E3610A-06B-S

S E R V I C E N O T E

E3610A Manual DC Power Supply

POSSIBLE SHOCK HAZARD

LOOSE AC MODULE

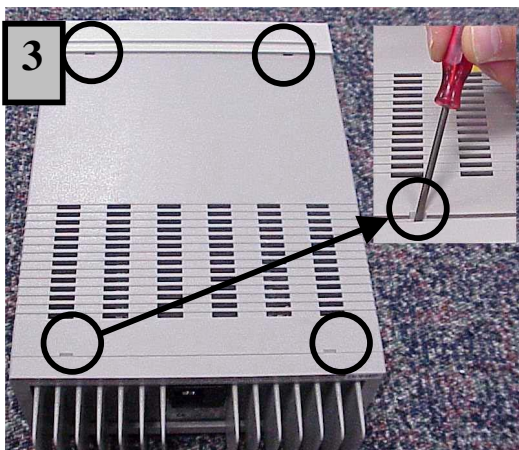
If the AC line cord is forcefully pulled in a side-to-side direction the AC Module can be pulled out of the rear heatsink, exposing the conductors that carry AC line voltage.

1. Make sure linecord is removed from outlet.
2. With linecord securely inserted in AC Module as shown, pull forcibly (2 times) in direction of arrow.

1. If the AC Module pulls out from Unit as shown it will need to be replaced.
2. If the AC Module remains in place it does not need to be changed. Put a mark on the AC input label in the lower left hand corner with indelible ink to indicate that the AC module has been checked. This label can be found below the AC module.

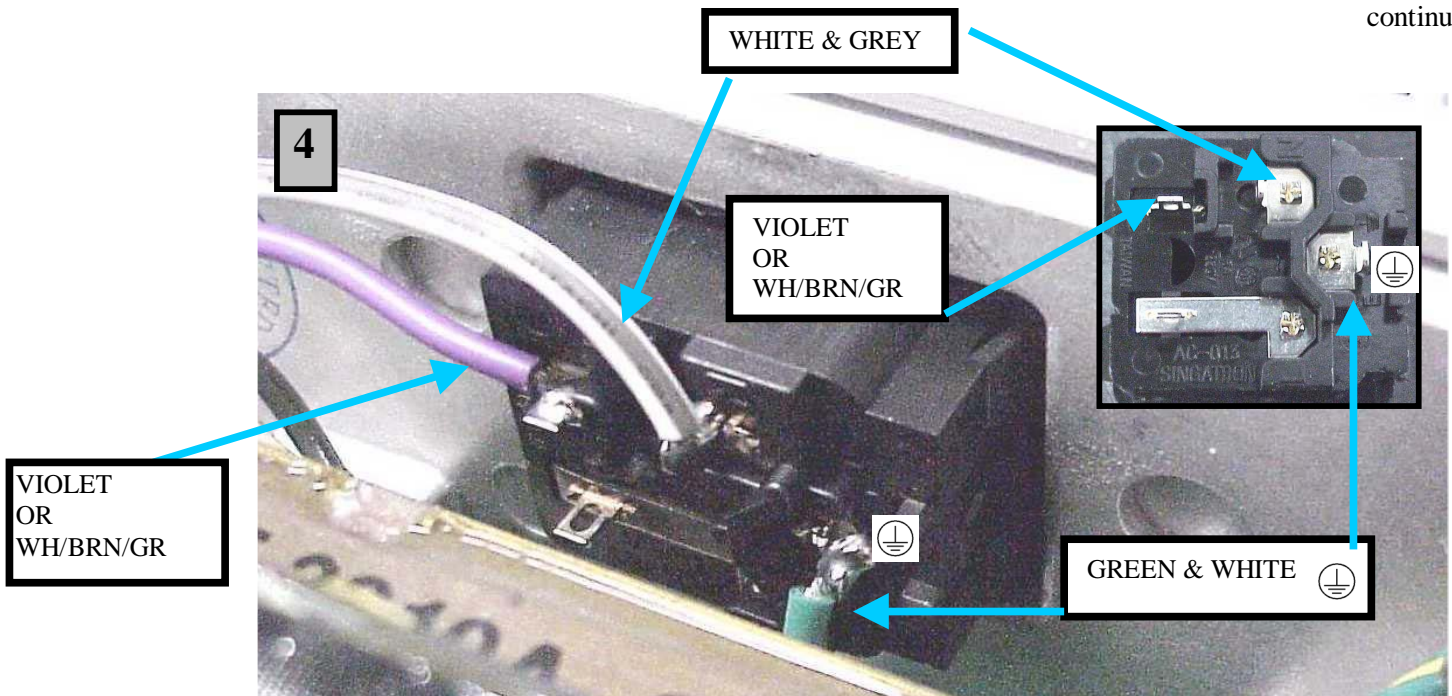
REMOVE COVER by prying Rear Bezel and Front Panel away from Cover in four places as shown. Then lift Cover off unit.

REPLACE MODULE with P/N 5065-6978. Before soldering perform “TEST FOR LOOSE AC MODULE” as shown in picture above. This will confirm that the new Module is secure. Solder wires and **REPLACE FUSE**.

CAUTION: WIRING MUST BE CORRECT OR HEATSINK COULD BE AT LINE POTENTIAL.

CAUTION: MAKE SURE SAFETY GROUND \oplus IS ATTACHED TO HEATSINK
